PARK 410 WEST		SHEET OF
		PRELIMINARY OVERALL AREA DEVELOPMENT PLAN 427.388 ACRE TRACT		
	CIVIL ENGINEERING CONSULTANTS SAN ANTONIO, TEXAS 512 826-5371		DESIGNED BY: N.W.B.	CHECKED BY: D.D.
	JOB NO. 107 DATE: 4-84		DRAWN BY: R.R.

PARK 410 WEST PRELIMINARY OVERALL AREA DEVELOPMENT PLAN

Re: Park 410 West POADP
File: 84-11-58-04
Revised: 10/10/85

Re: Park 410 West Preliminary Plan
File #: 84-11-58-04 P.O.A.D.P.

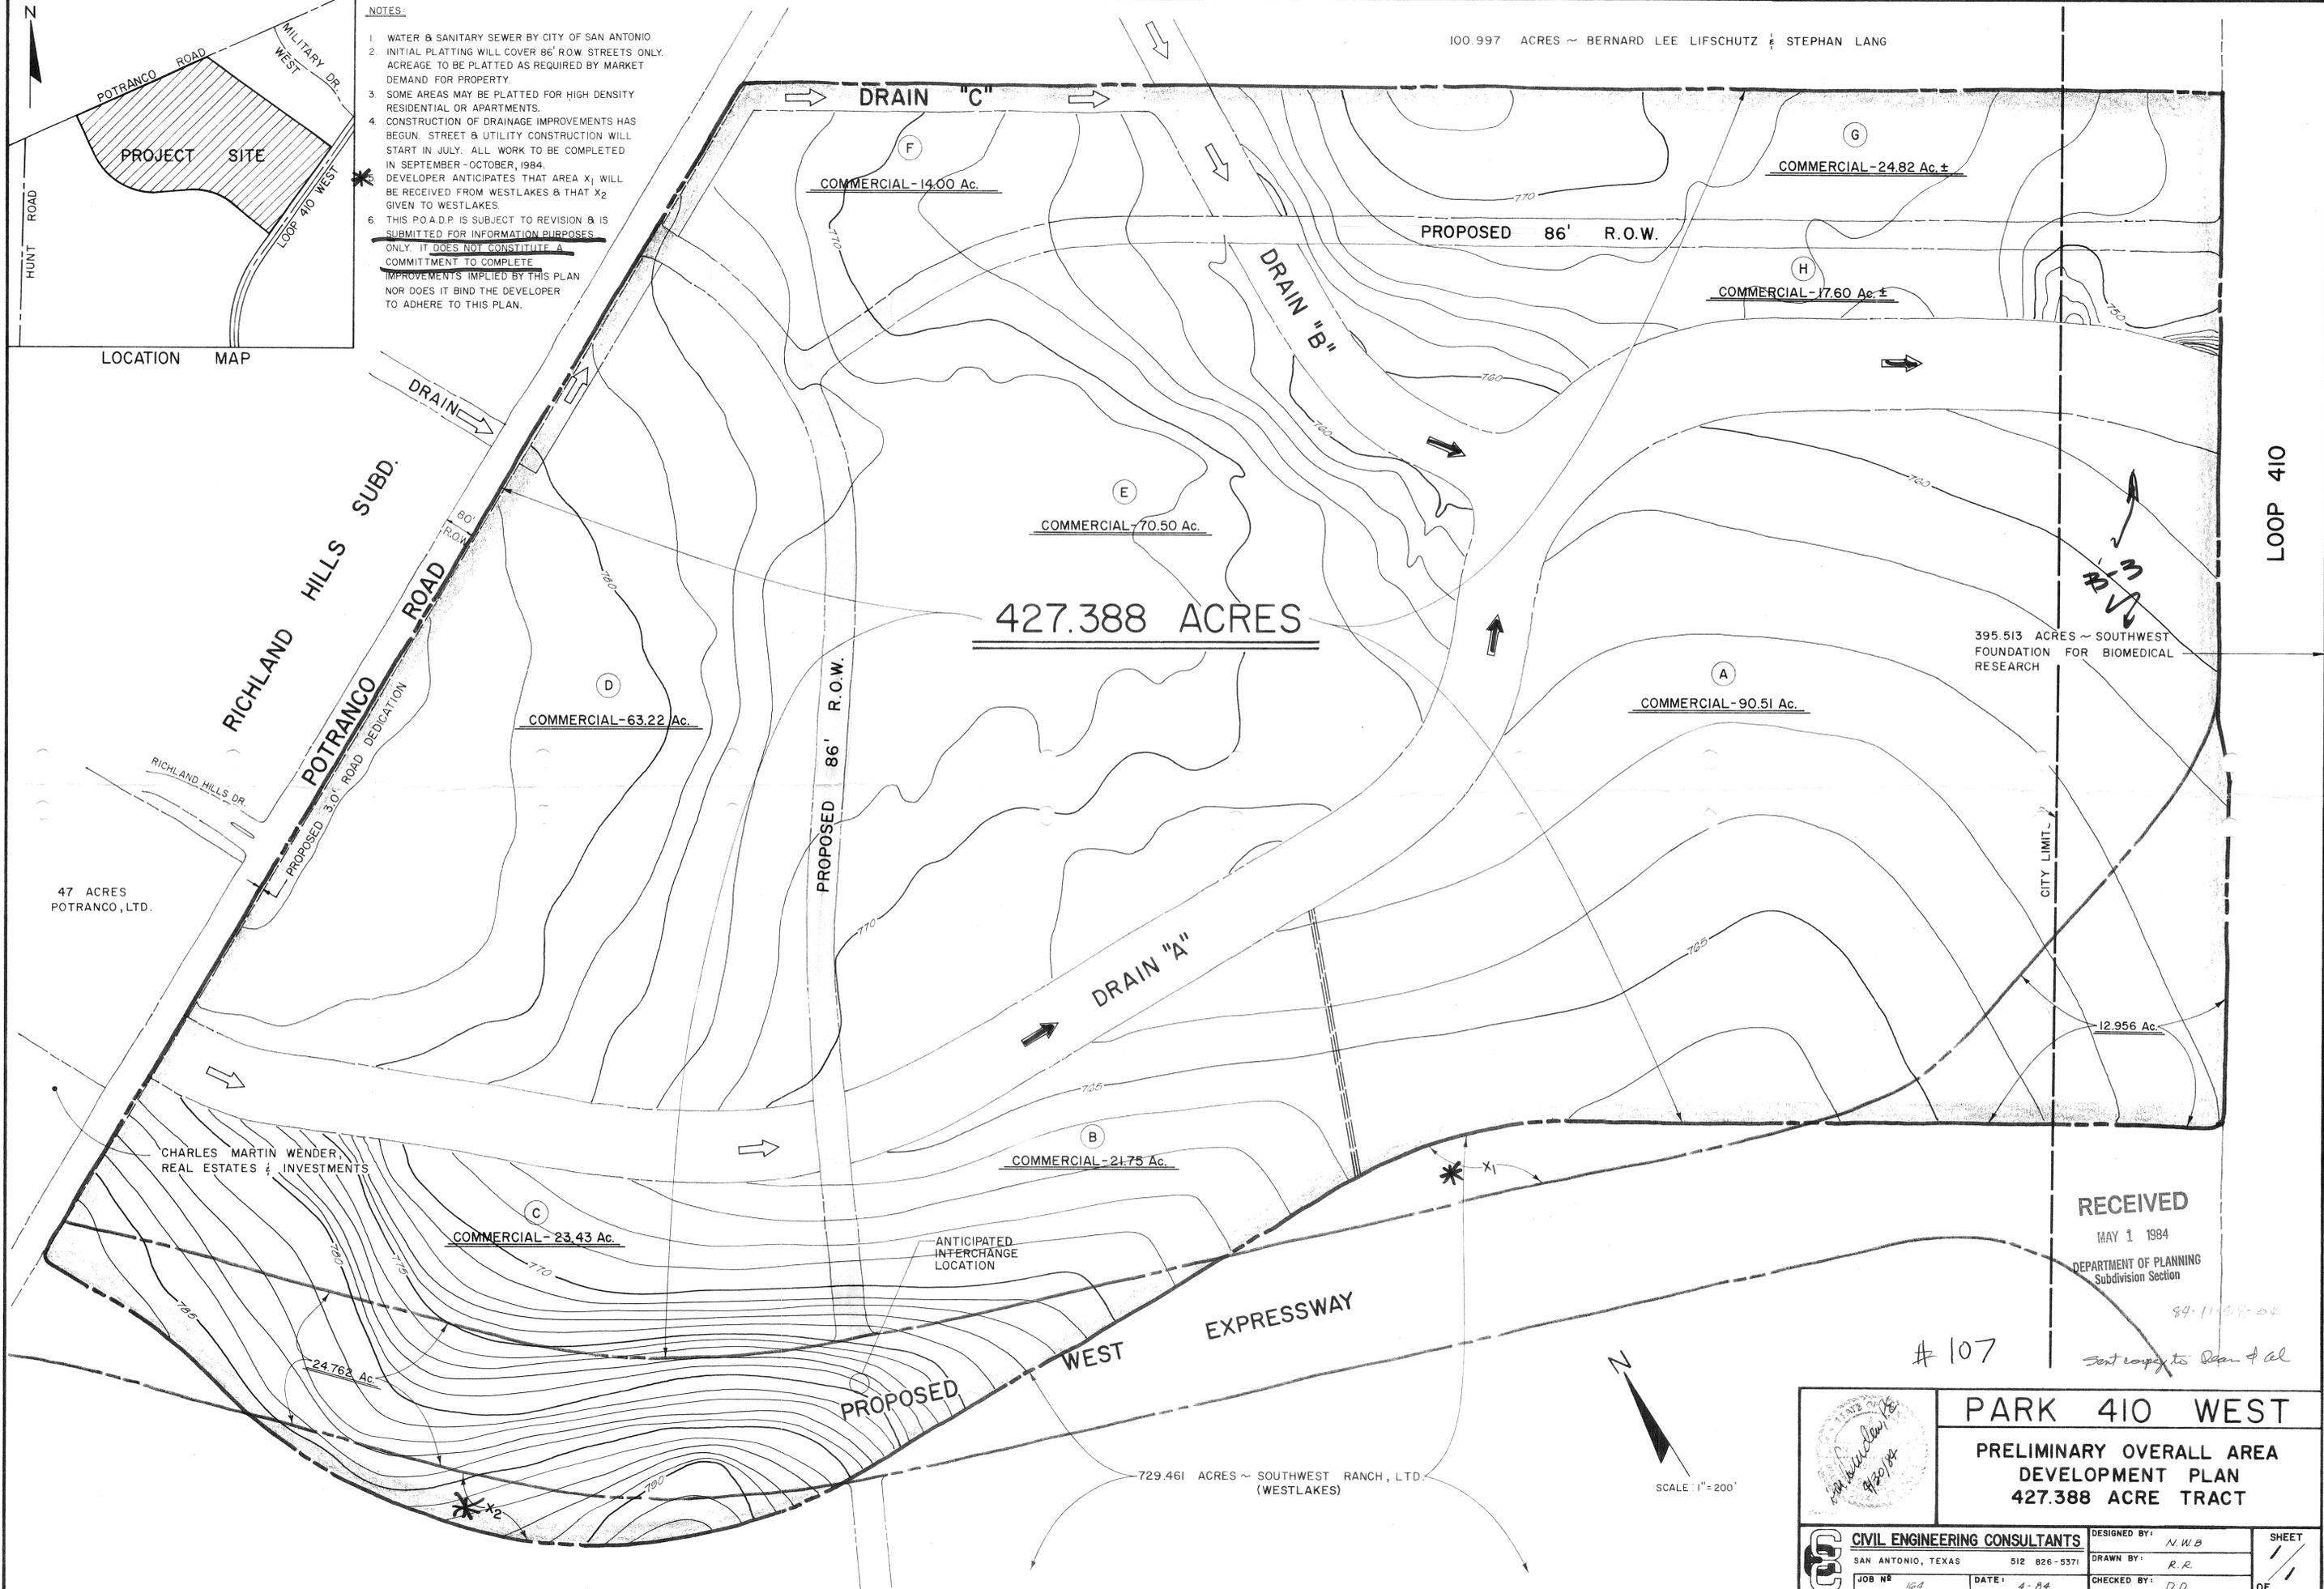
Comments: Staff concurs with the planned design. However, it is recommended that any potential change in location of the north-south 86' facility be coordinated with the property owner to the south. (Southwest Ranch L.T.D.)

PARK 410 WEST
PRELIMINARY OVERALL AREA DEVELOPMENT PLAN

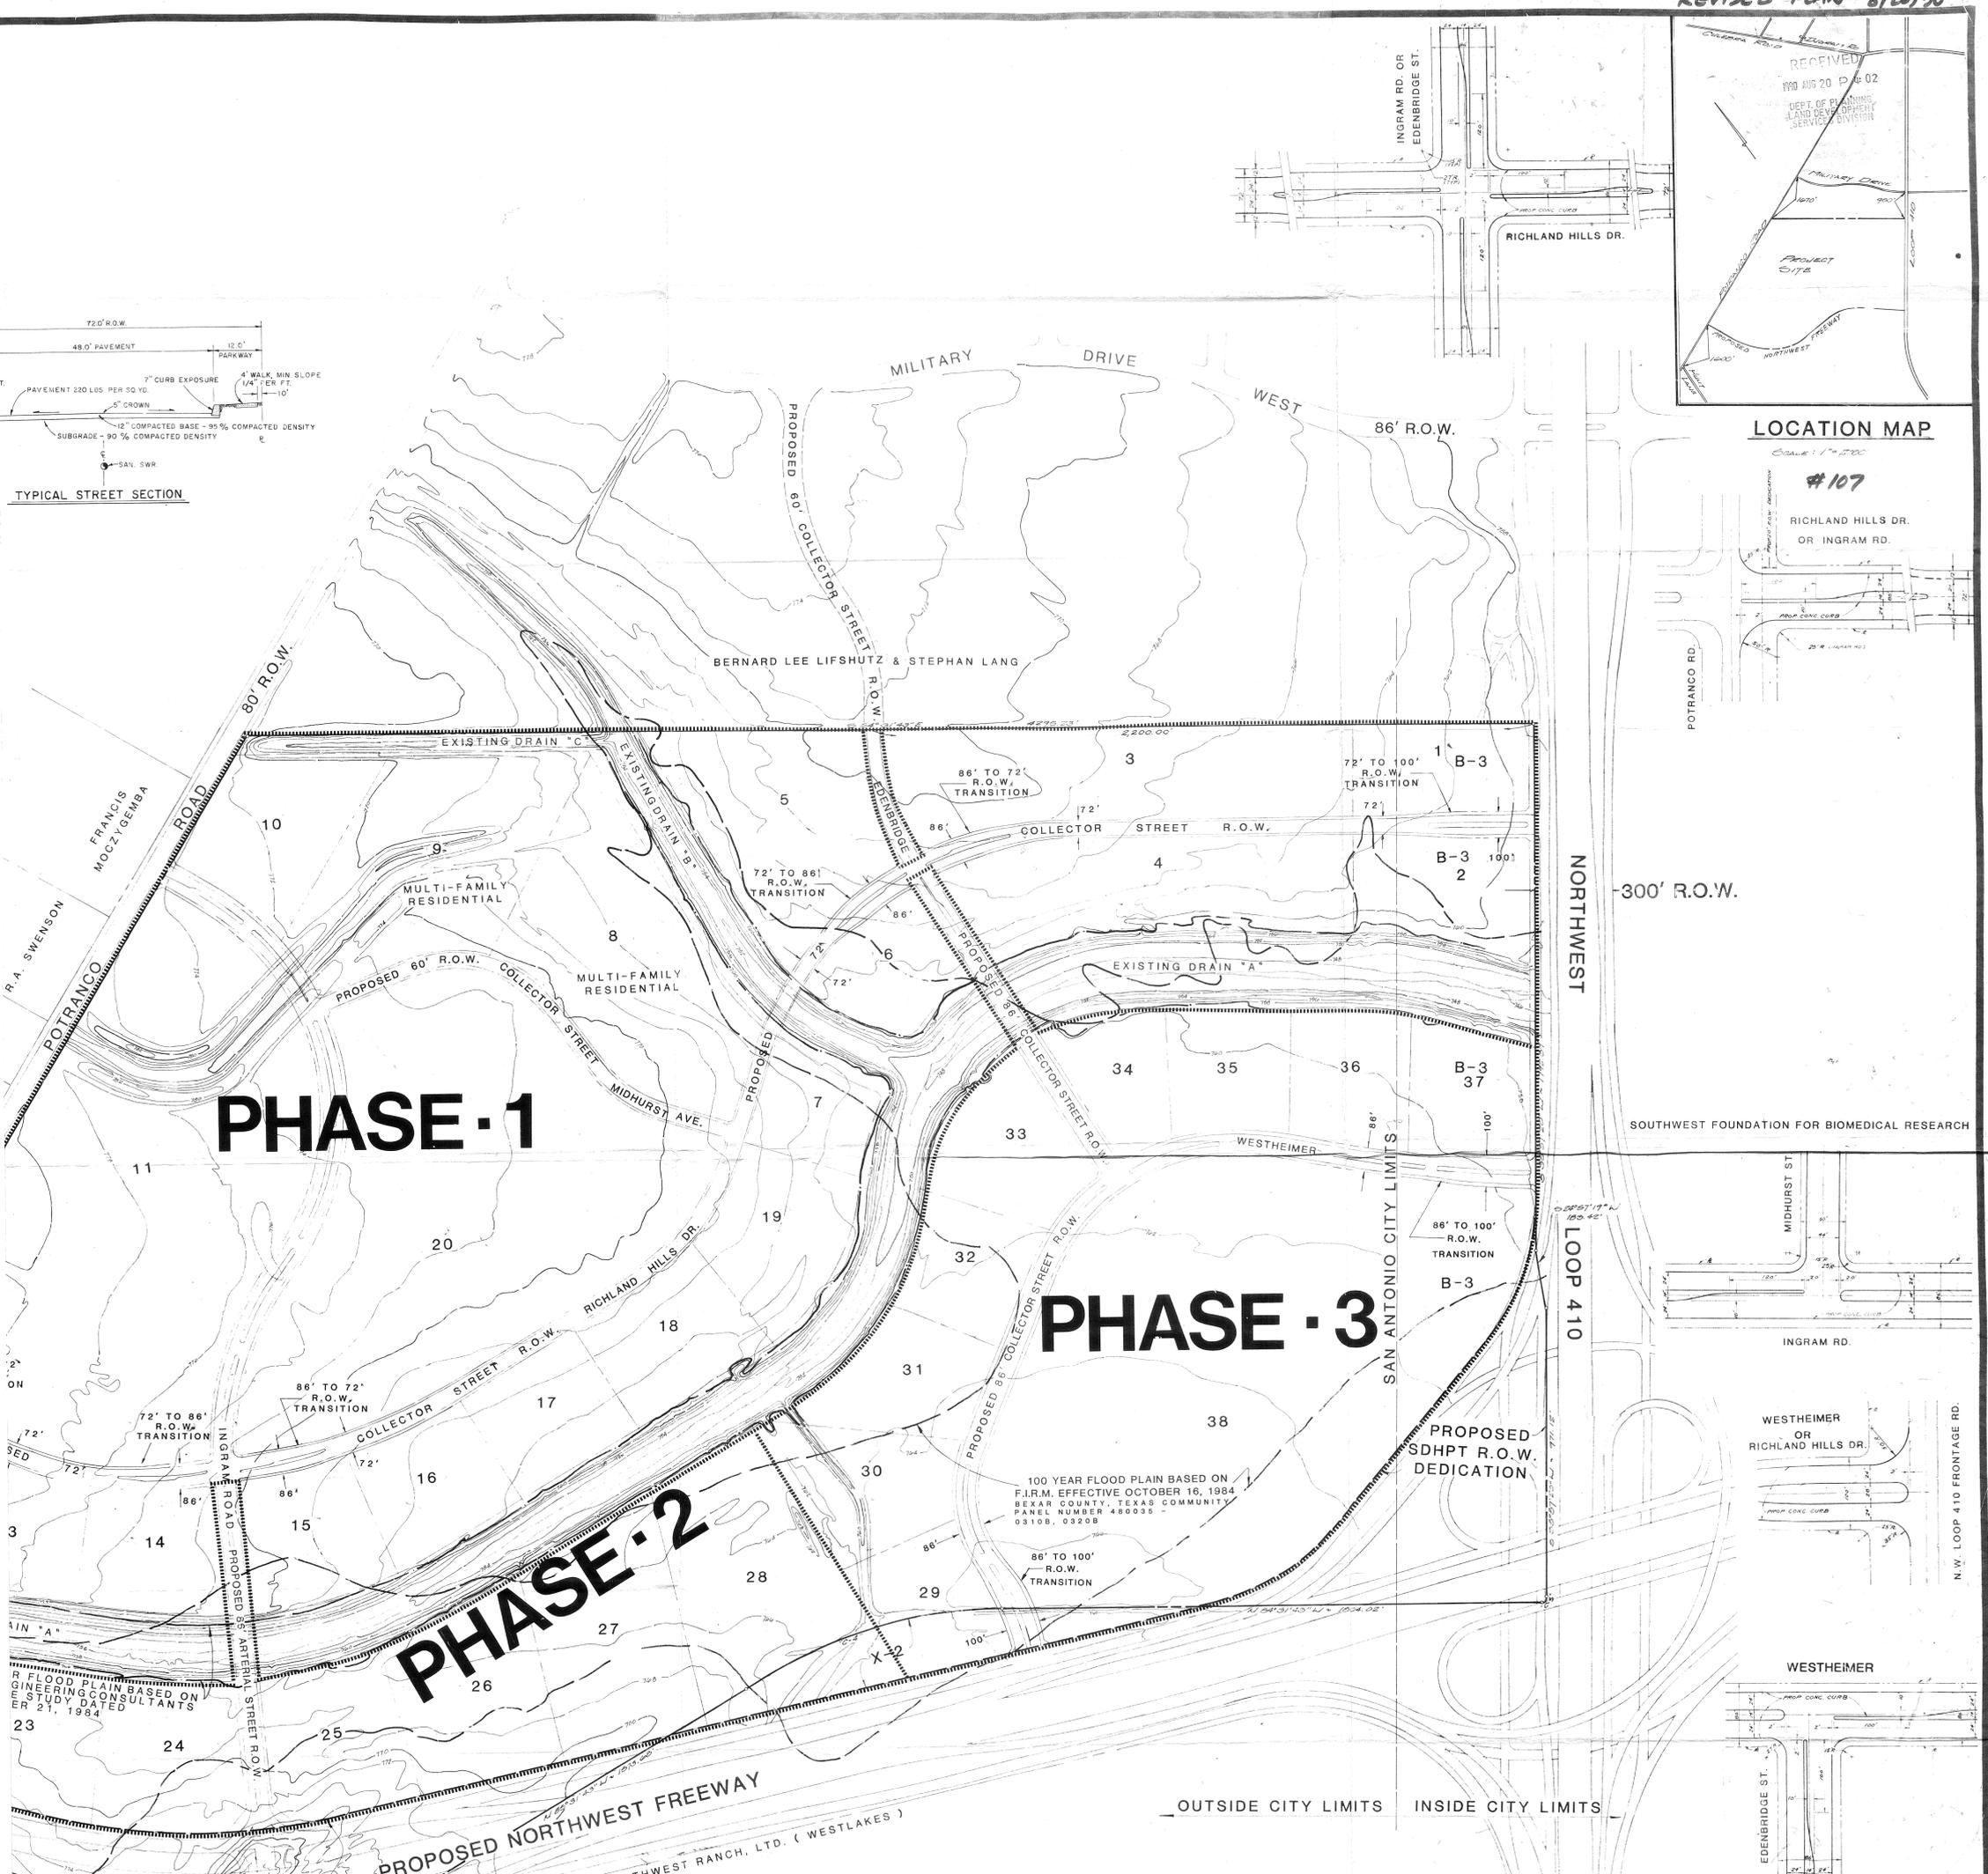
The POADP has been revised to reflect changes made to the phase layout and the proposed street right-of-way for Richland Hills Drive. It also incorporates intersection details. These intersection details are provided to show proposed left-hand turn lanes, and right-of-way transitions. Both of these revisions and additions have been made based upon recommendations by David Stietle, City of San Antonio Assistant Public Works Director, during a meeting between Mr. Stietle and me.
